re: **Response to City Comments**
 Proposed Residential Development
 475 Terry Fox Drive – Ottawa, Ontario

file: PG7418-MEMO.01 Revision 4

Further to your request and authorization, Paterson Group (Paterson) has prepared the current memorandum to provide geotechnical responses to City of Ottawa comments dated August 29, 2025, and revised to consider the response to those comments in a letter dated November 24, 2025. The following memorandum should be read in conjunction with the current Geotechnical Report PG7418-1 Revision 4 dated April 17, 2026, prepared for the aforementioned site.

FIGURE 1

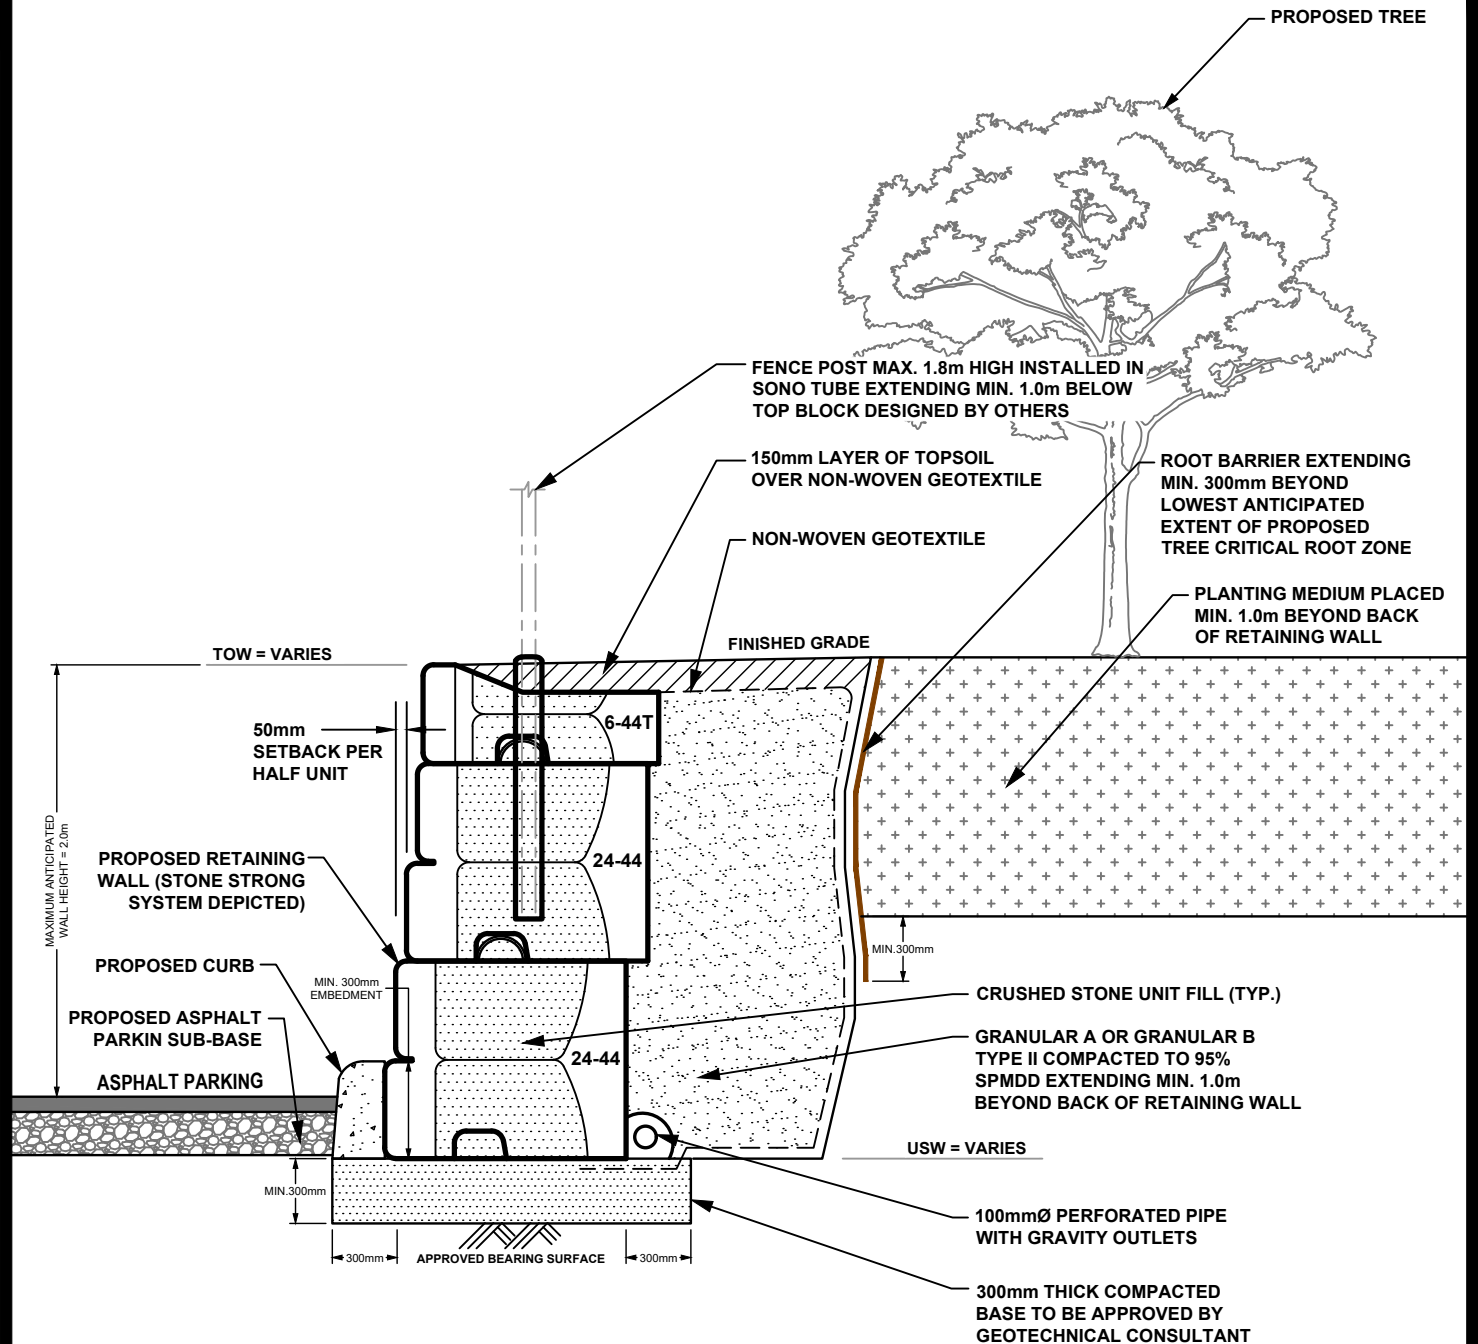
Comment 7: *Cross-sections are required for the proposed retaining walls.*

Comment 74: *[City's response to previous deficiency #7]: Noted, this comment has been moved under the comments section. Please provide the actual cross-sections of the proposed retaining wall once available.*

Response: Cross-sections of a typical segmental block retaining wall design that will be required for the proposed retaining wall during the detailed design stage has been appended to this memorandum in response to this comment. The attached typical detail provides an example of the type of retaining wall structure that is considered feasible and suitable for the subject site from a geotechnical perspective.

Response: This comment has been acknowledged; this will be provided at the detailed design stage when the retaining wall design is typically and most appropriately complete.

SLIDEINTERPRET 9.031	Project Ironclad Developments Inc. Slope Stability Analysis 475 Terry Fox Drive, Ottawa, Ontario		
	Figure No. Figure 1A - Section A - Proposed Conditions - Static Loading		
	Drawn by: NFRV	Company: Paterson Group	
	Date: 2026-01-05	File No. PG7418

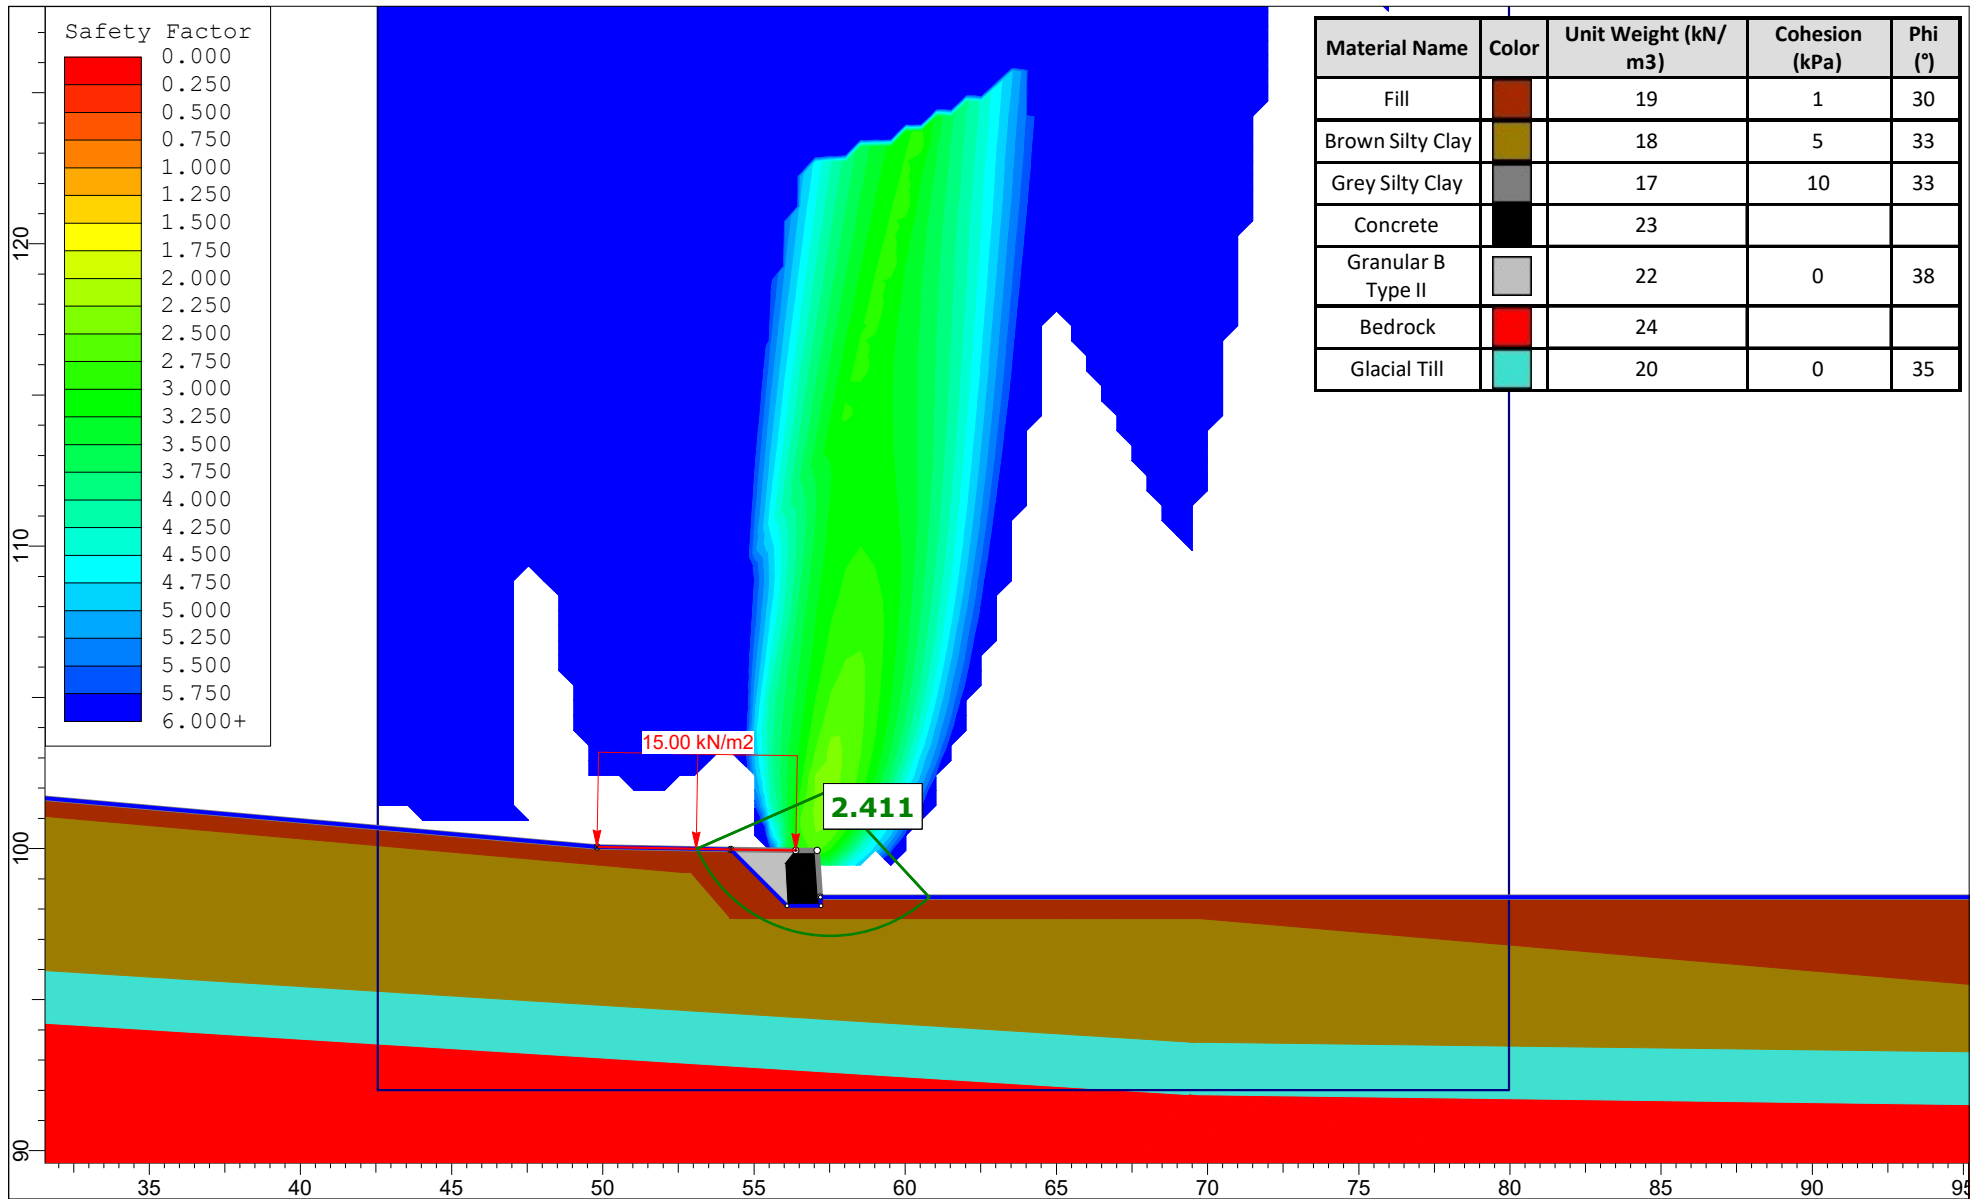
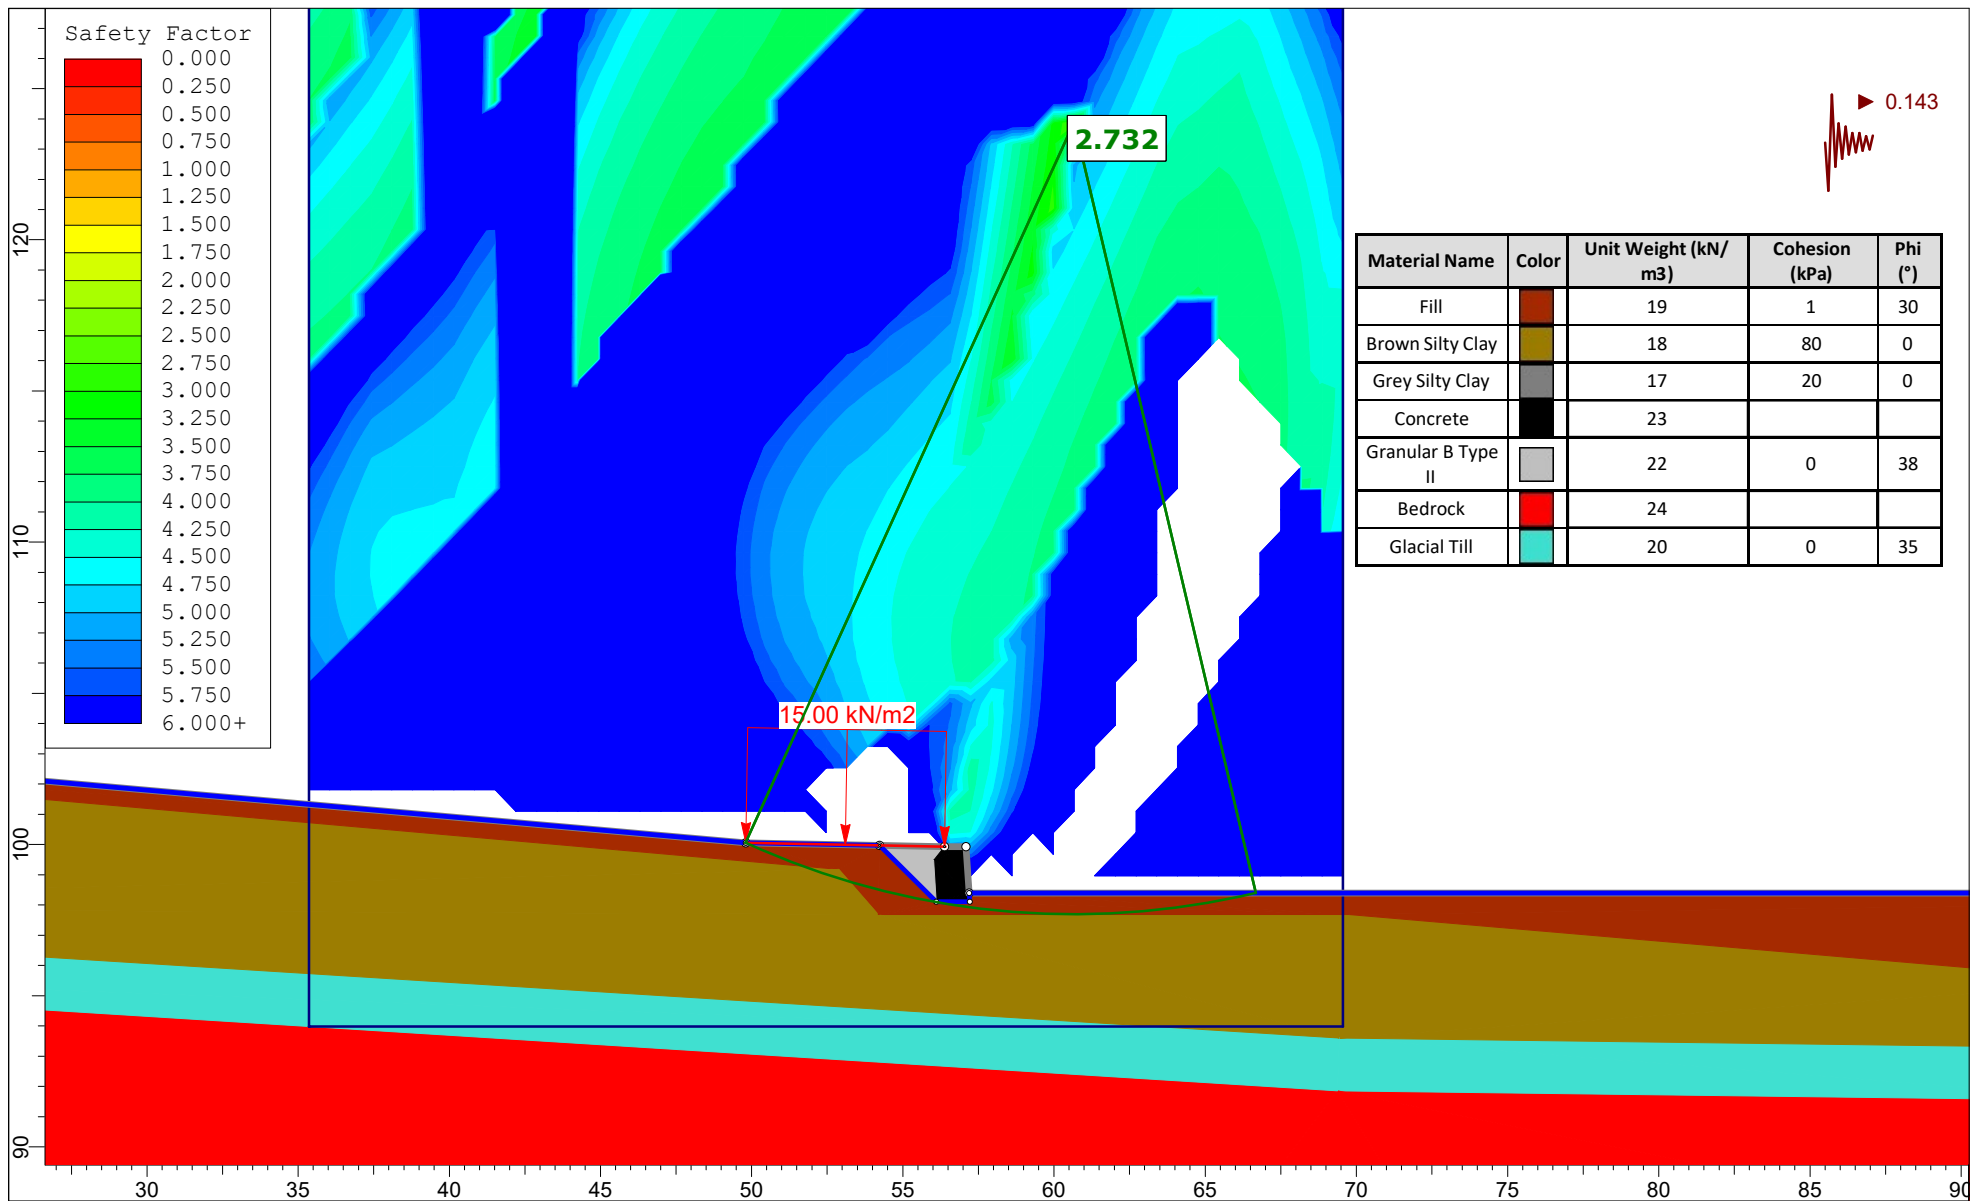
Comment 6: *Please coordinate with the civil consultant to confirm if the proposed retaining walls on site will require a global stability analysis report and drawings. These documents will be required to make for a complete submission if the proposed retaining walls are greater than 1.0 m in height.*

Comment 73: *Thank you for providing a global stability analysis for the highest section of the retaining wall. Although this is the highest section of the retaining wall, can you confirm that it is also the most critical cross-section that could be analyzed for this site? Perhaps the highest section of the retaining wall may not be the most critical if elsewhere along the wall larger trees are being proposed closer to the top of wall? Please confirm.*

Response: Based on Paterson's review of the currently proposed grading concepts, retaining walls reaching up to 1.54 m in height will be required. Based on this information, Paterson has subsequently prepared a global stability analysis of the highest and most critical segment of the proposed retaining wall structure based on the current civil design drawings. This analysis considers a surcharge of 15 kPa, equivalent to typical traffic loading, representing trees to consider their presence along the top of the wall area.

Based on our review, the factors of safety for the static and seismic loading cases exceed the required minimum factors of safety of 1.5 and 1.1, respectively, and are considered acceptable from a geotechnical and global stability perspective. The analysis was undertaken using SLIDE, a computer program which permits a two-dimensional slope stability analysis using several methods including the Bishop's method, which is a widely used and accepted analysis method. The cross-sections are appended to this memorandum.

Response: Reference should be made to our response to Comment #7. In summary, Paterson has confirmed that the section considered is the most critical section and an additional surcharge has been applied to consider the presence of trees equivalent to typical traffic loading.
